APICAL INDUSTRIES, INC.
dba DART AEROSPACE

ENGINEERING CHANGE NOTICE NO. 05397		SHEET 1 OF 1	
DWG NO. 647.7700	REV: A	PREPARED BY T. CROSS	DATE: 05/02/16
EFFECT ON DWG ☐ INC. ☒ UNINC.			
DWG TITLE: STRUT ASSY			
APPROVED BY: ENGR [Signature]	MFG [Signature]	QC [Signature]	EFF: [Signature]
REASON: REVISED DIMENSION			CURRENT ORDER
TRANSACTION CODES (TC): A-ADD C-CREATE R-REVISE D-DELETE			ECR: 16-028
			ACTION LIST: 1.

APICAL INDUSTRIES, INC.
dba DART AEROSPACE

ENGINEERING CHANGE NOTICE NO.

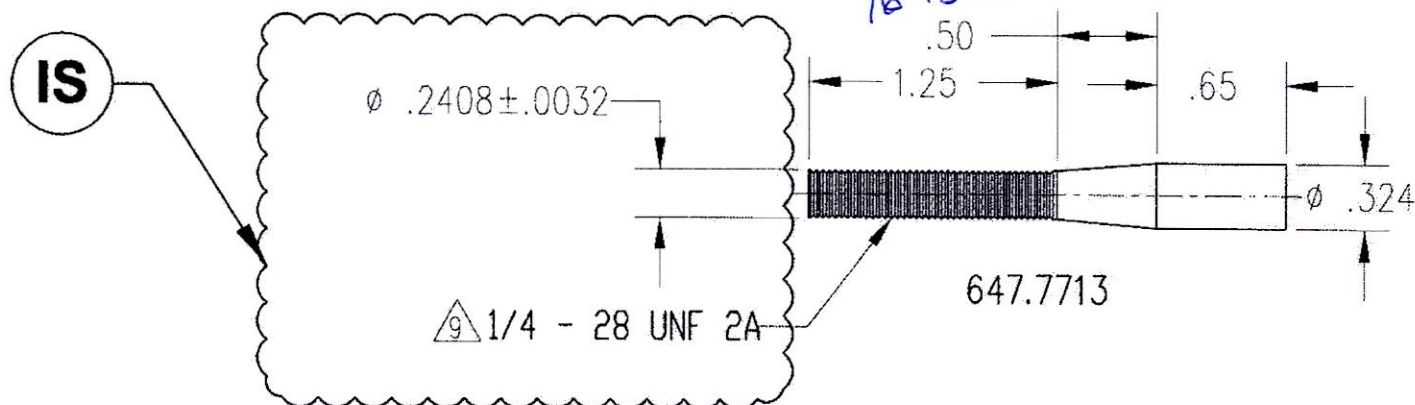
SHEET 2, ZONE D4 IS:

SHEET 1, NOTES IS:

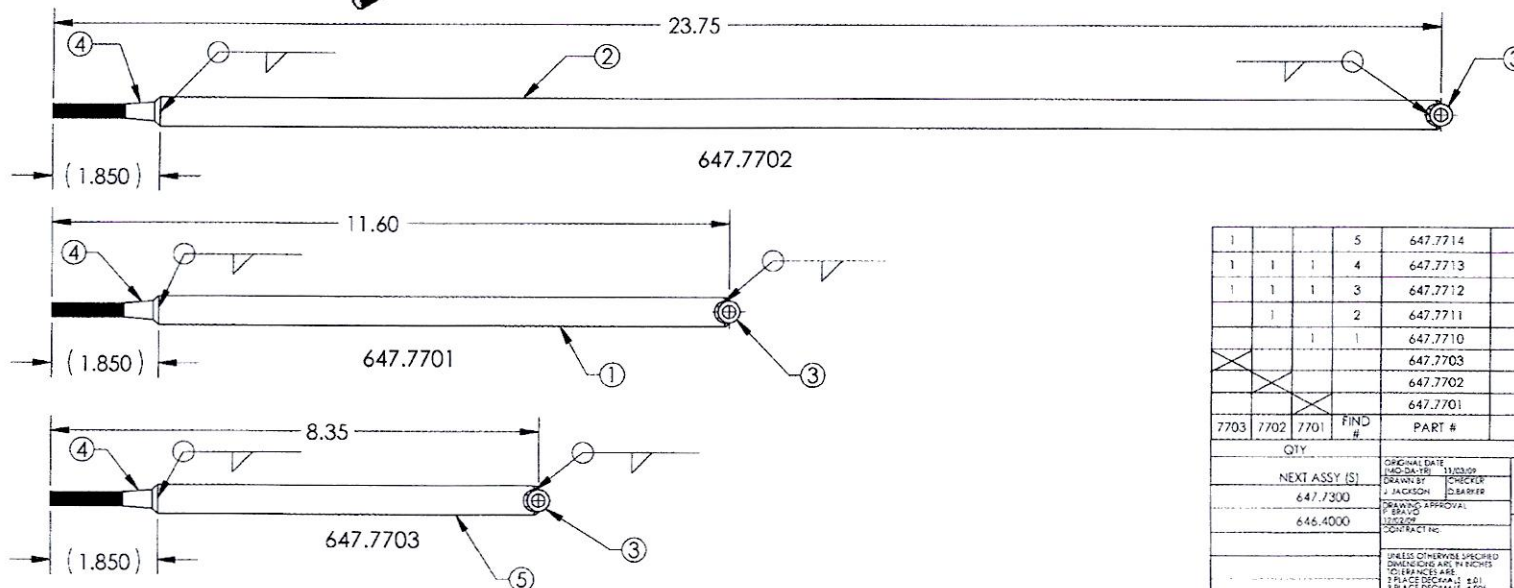
REASON: REVISED FINISH CALLOUT AS PER ECR 15-209

- 1 MATERIAL: 4130 STEEL PER AMS-T-6736, .50" OD, .083" WALL THK.
- 2 MATERIAL: 4130 STEEL PER AMS-T-6736, .375" OD, .075" WALL THK.
- 3 MATERIAL: 4130 STEEL PER AMS-T-6736, .324" OD.
- 4 FINISH: PRIME IAW MIL-P-2337J TYPE I CLASS N; 1-2 MIL MAX
5. DEBURR AND BREAK ALL SHARP EDGES
6. IDENTIFY IAW MPP-120.
- 7 WELD IAW MIL-STD-2219. TIG WELD WITH FILLER ROD
- 8 FINISH: CAD PLATE IAW QQ-P-416F CLASS I TYPE II
- 9 MASK THREAD PRIOR TO FINISH

1. MATERIAL: 4130 STEEL PER AMS-T-6736, .50" OD, .083" WALL THK.
2. MATERIAL: 4130 STEEL PER AMS-T-6736, .375" OD, .075" WALL THK.
3. MATERIAL: 4130 STEEL PER AMS-T-6736, .324" OD.
4. FINISH: PRIME IAW MIL-P-2337J TYPE I CLASS N; 1-2 MIL MAX
5. DEBURR AND BREAK ALL SHARP EDGES
6. IDENTIFY IAW MPP-120.
7. WELD IAW MIL-STD-2219, TIG WELD WITH FILLER ROD
8. FINISH: CAD PLATE IAW MIL-C-5541 CLASS 1A
9. MASK THREAD PRIOR TO FINISH
